RE: OSDS Plan  
3168 Jennings Chapel Road, Woodbine, MD. 21797

**RE:** OSDS Plan  
3168 Jennings Chapel Road  
Woodbine, MD 21797

The OSDS Plan for has been reviewed with the following comments:

**ONSITE SEWAGE DISPOSAL SYSTEM DESIGN PLAN**

INSTALLATION:

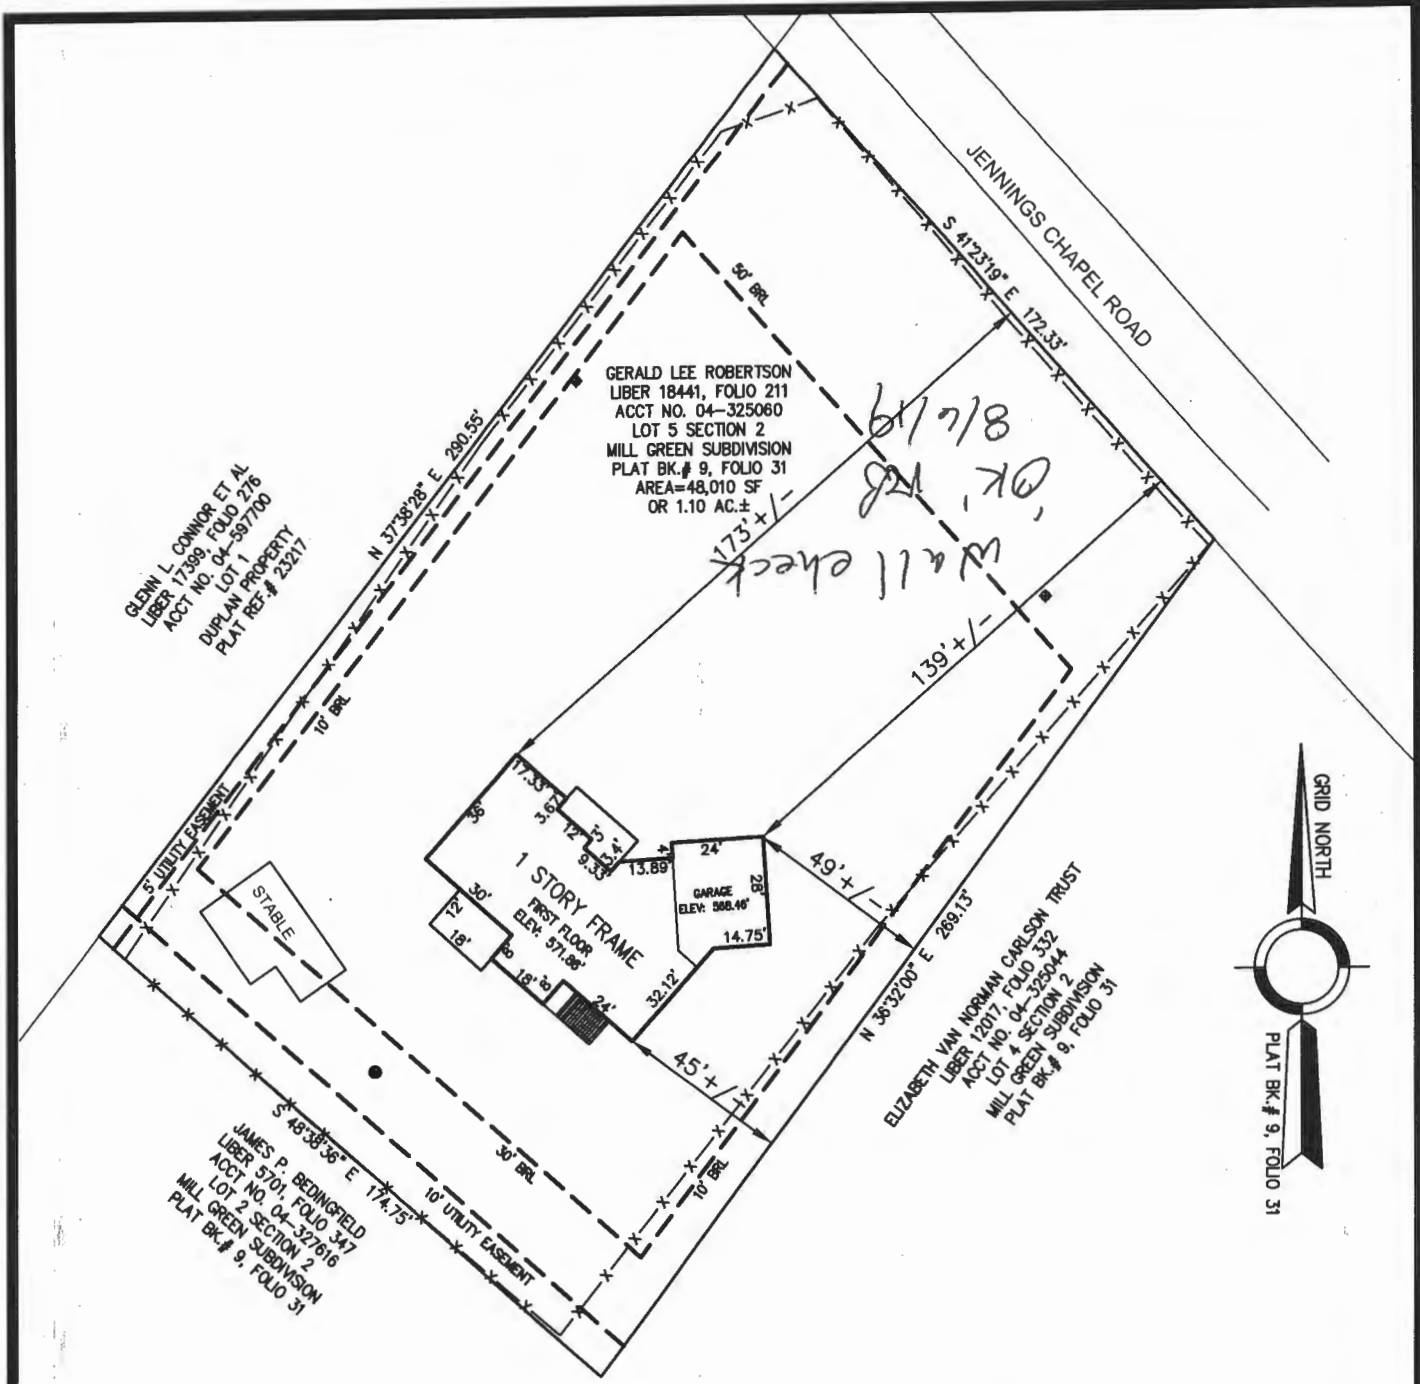
08/29/2019 45' OF UPPER TRENCH COMPLETE. TANK BEING SET. APPEARS WATERTIGHT. 08/30/2019 LOWER TRENCH COMPLETE. INLET @ 3.5' BELOW GRADE. COR. AET UPPER TRENCH DID NOT HAVE FALL FROM DBOX. (PM) CORRECTED FALL. SEWER LINE COMPLETE, REINS. SHC FOLLOW UP W/ LOW TRENCH INLET. 09/03/2019 PER KMW, TRENCHES OK; D BOX HAS ONE SPEED LEVEL DUE TO CORRECTION

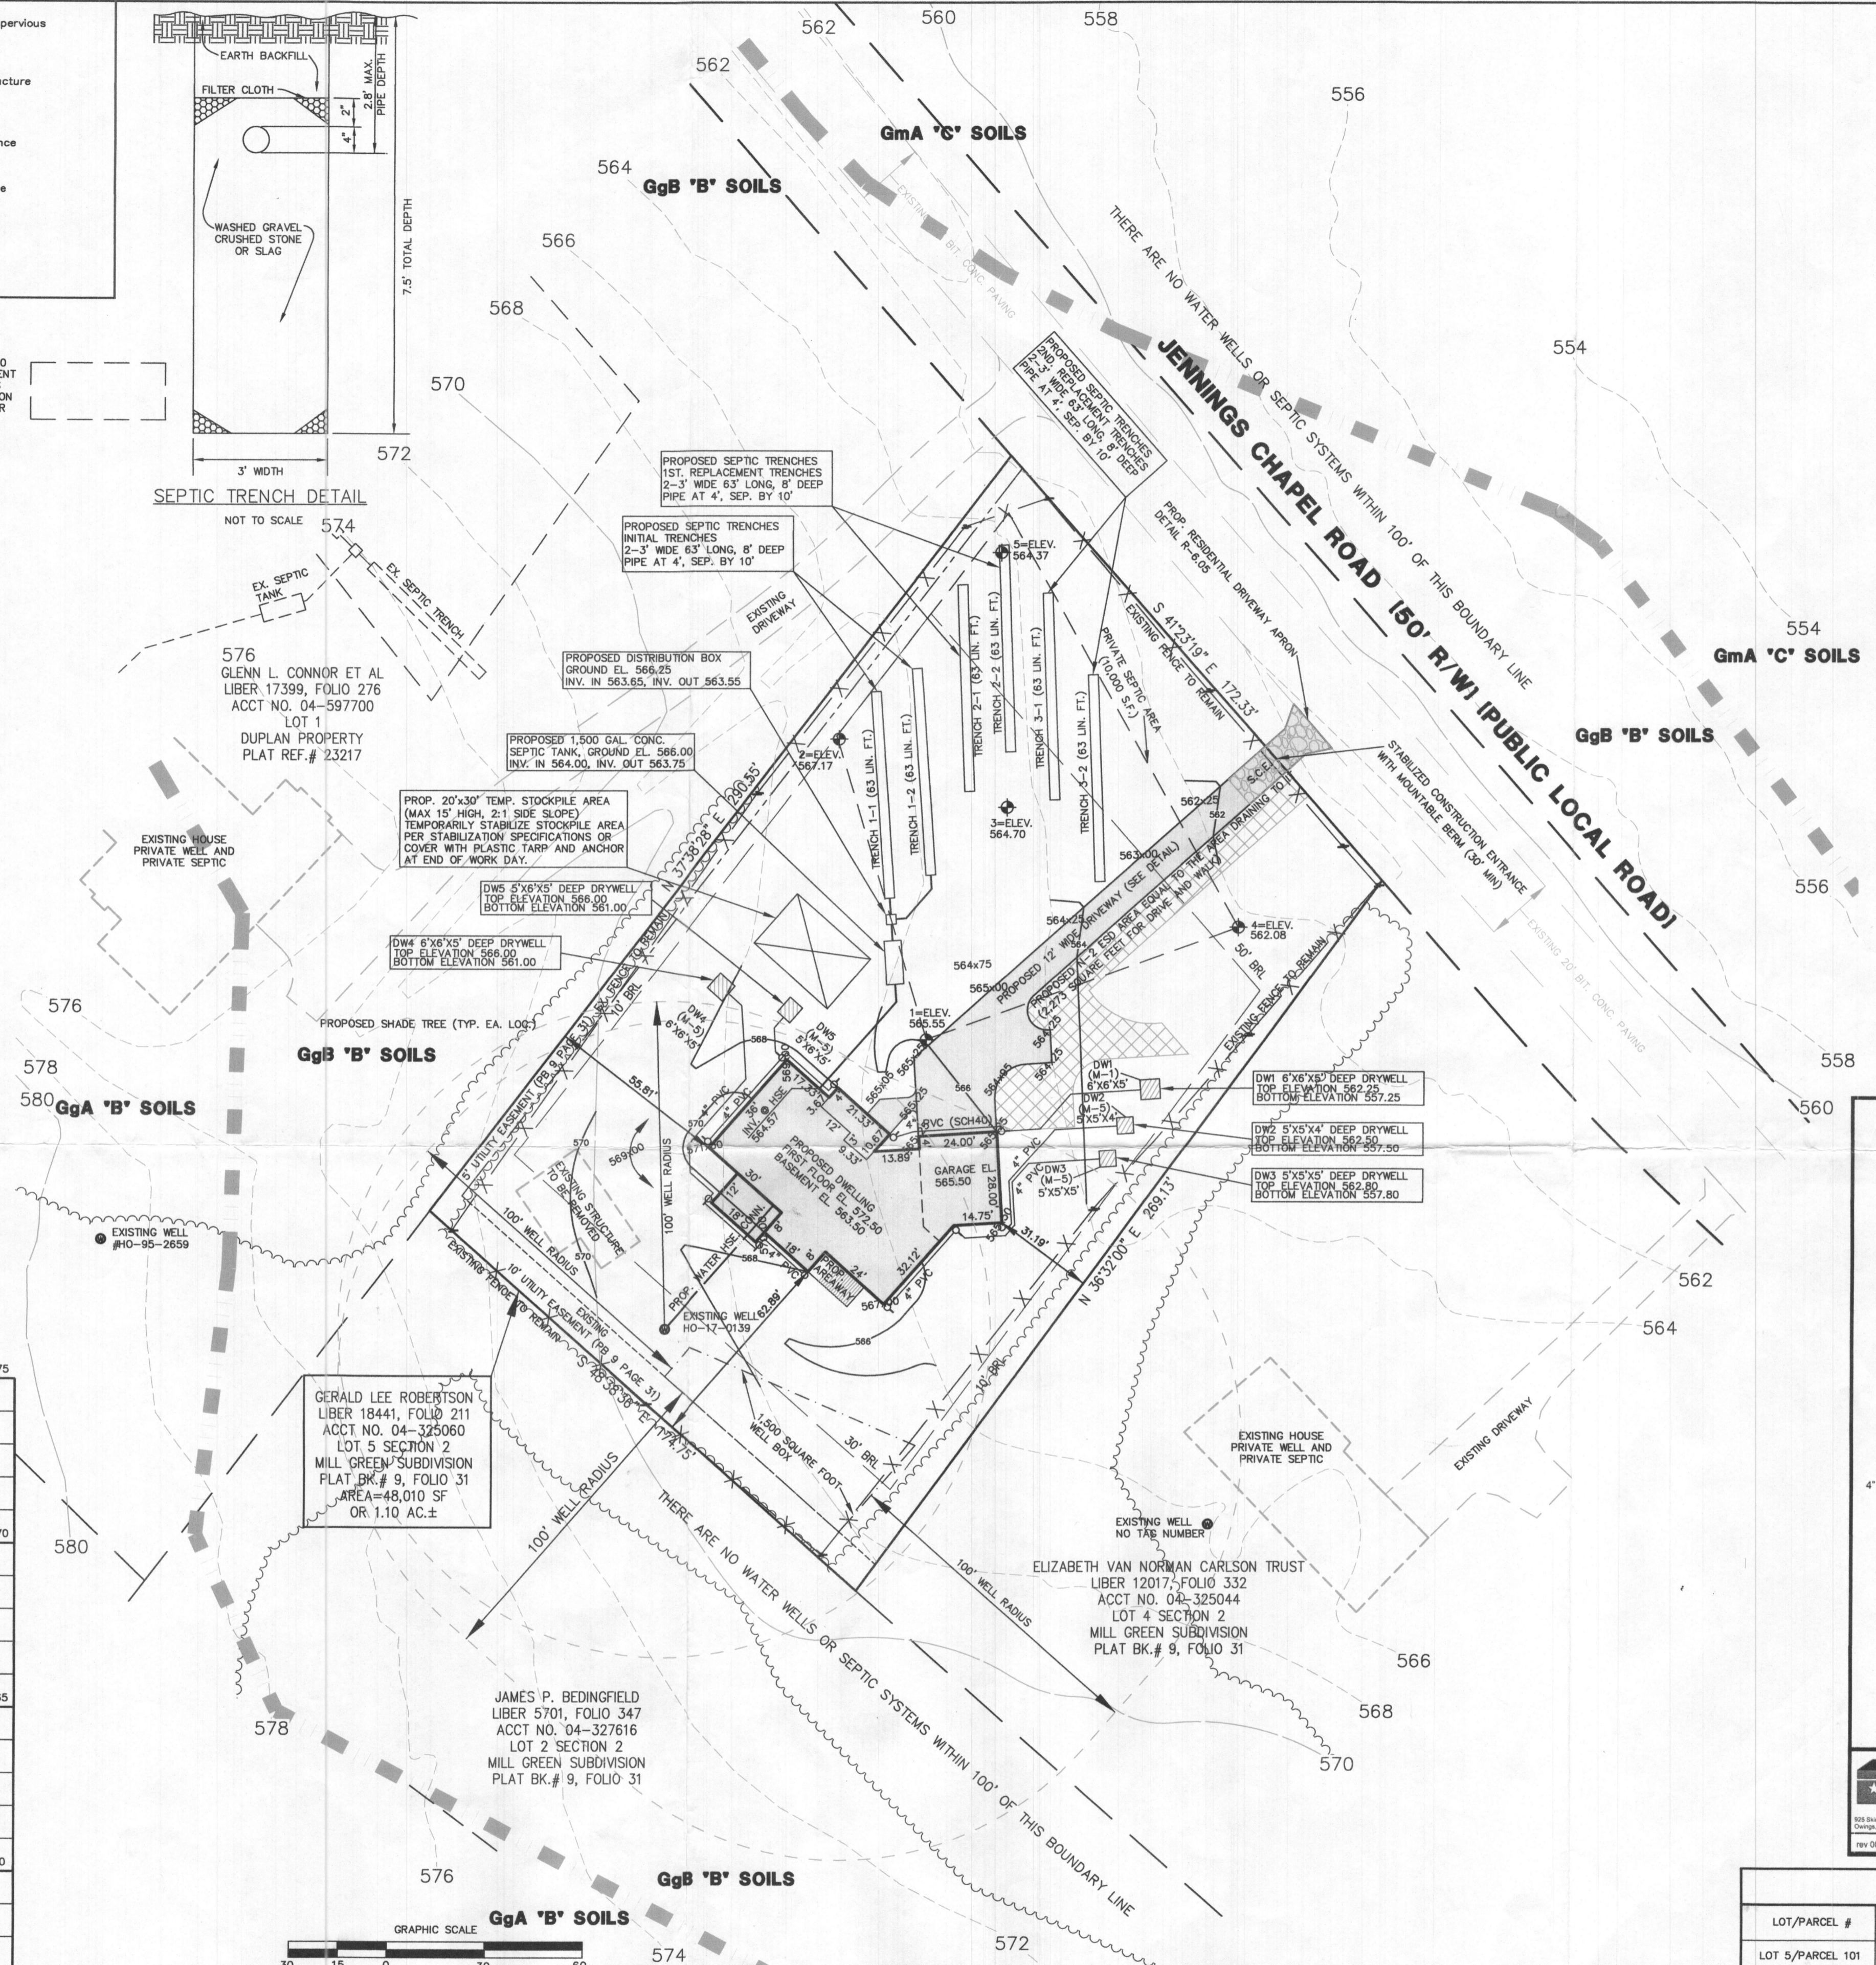
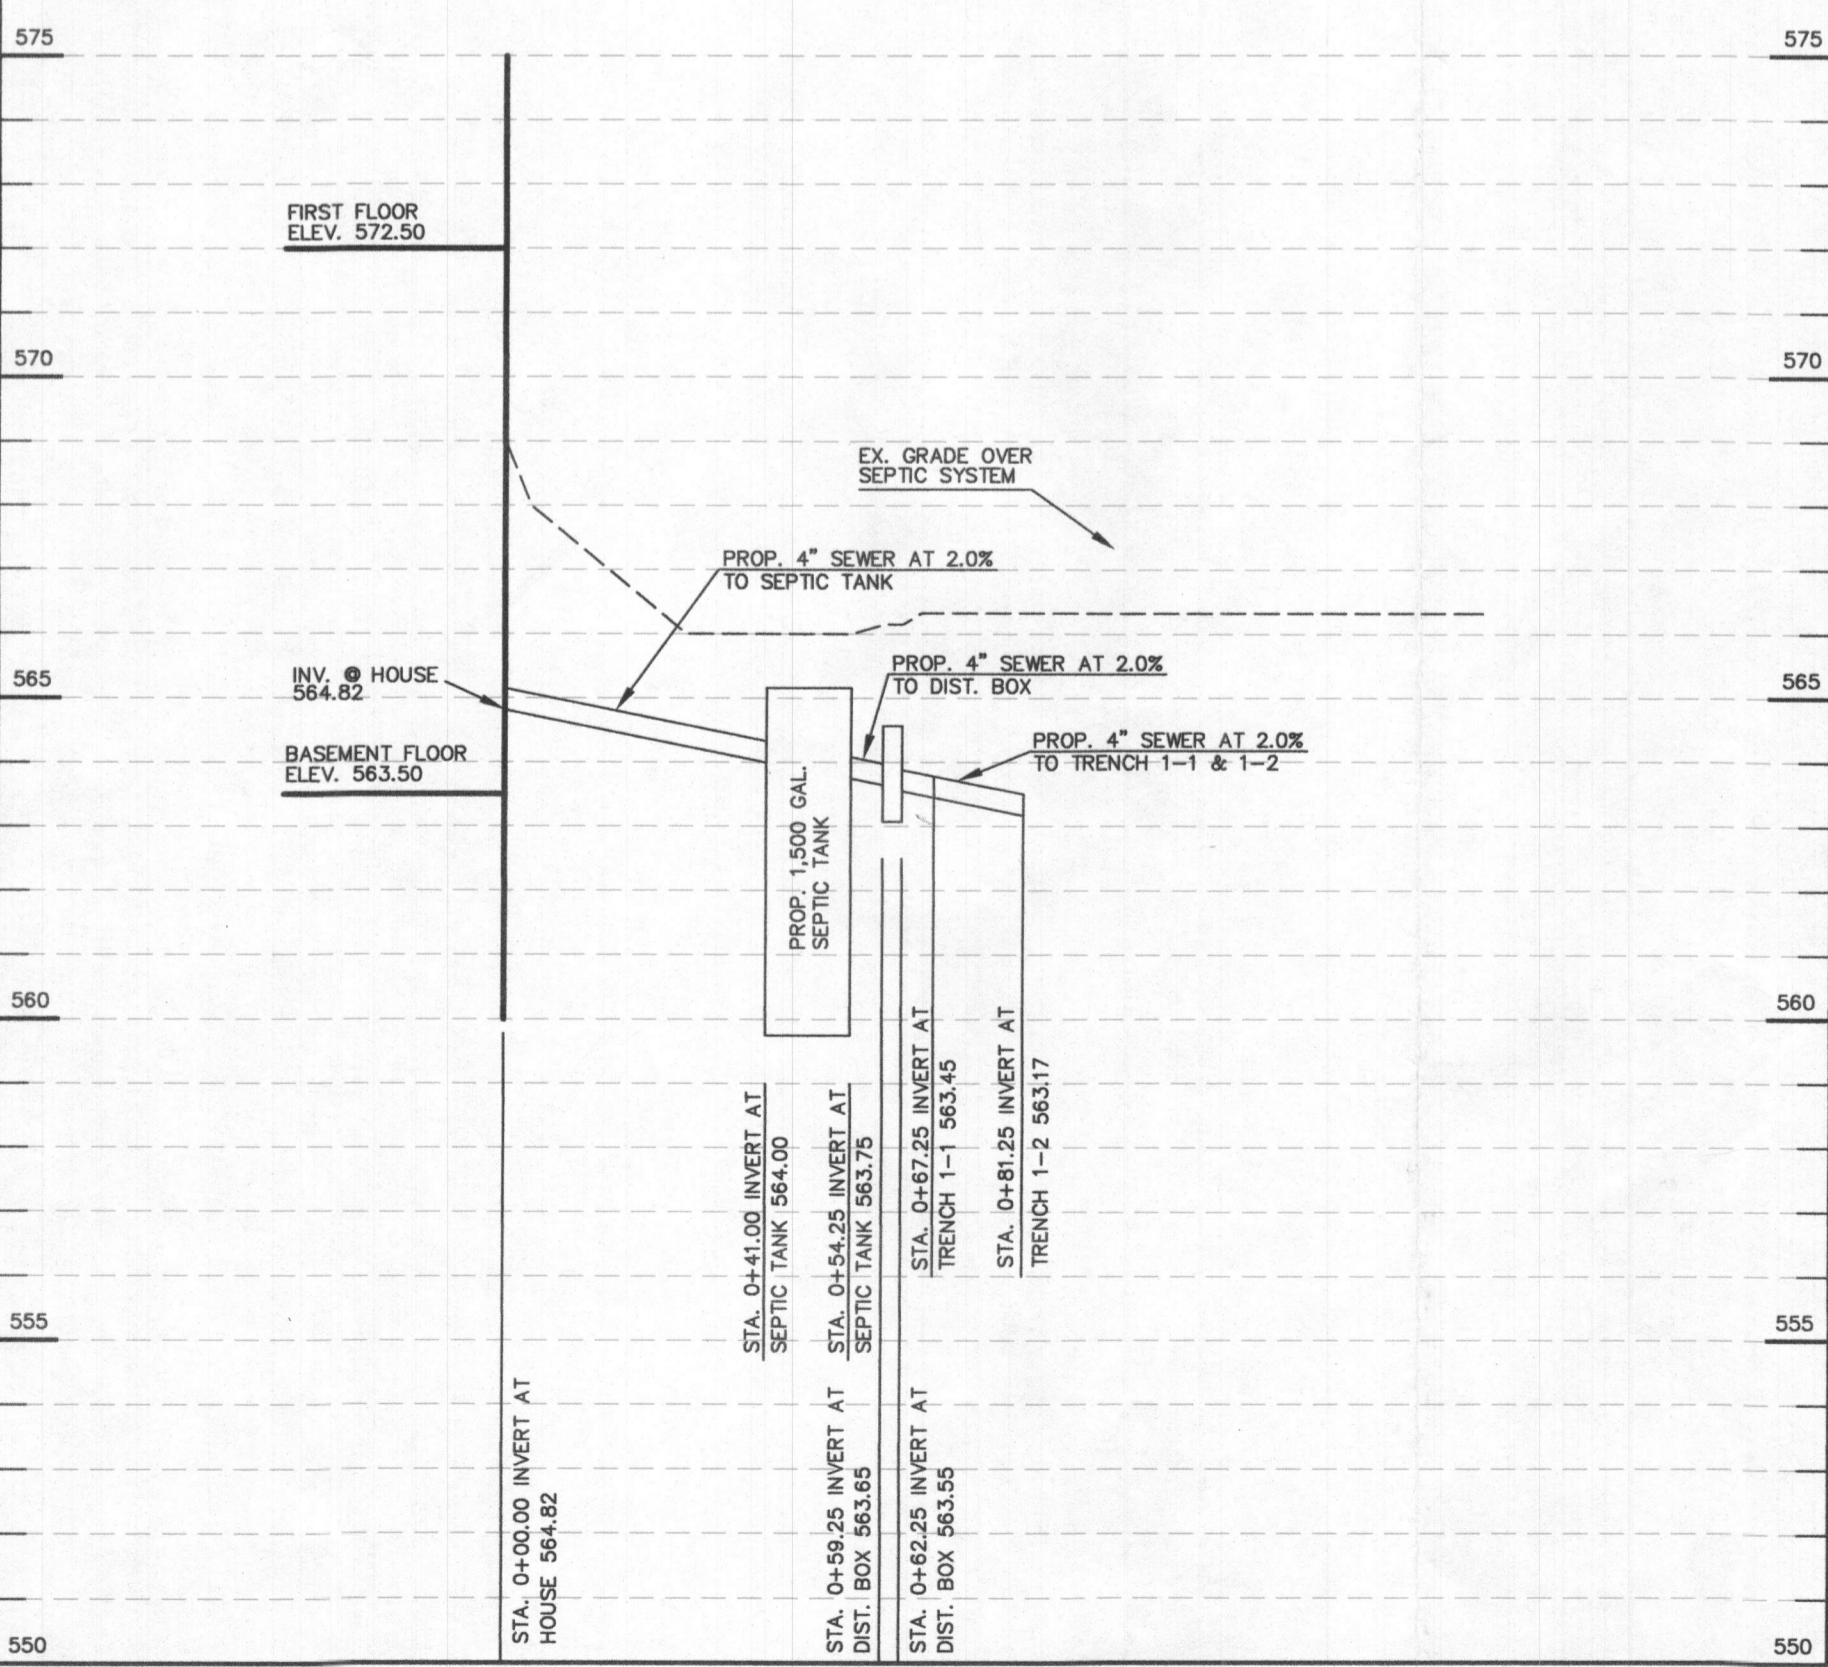
The septic trench information indicates a trench depth of 7 feet and a side wall credit of 0.50. Effective area depth doesn't start until 4.5 feet. In order to receive a sidewall credit of 0.50, the minimum trench depth should be at least 7.5 feet.

$W+1/+W+2+2(D)$

$3+2/ 3+1+2(3) = 0.50$

I can redline the plan with the correct bottom trench elevations. i.e. trench 1 – 1 = 558.75 etc. or you may revise and send new copies.
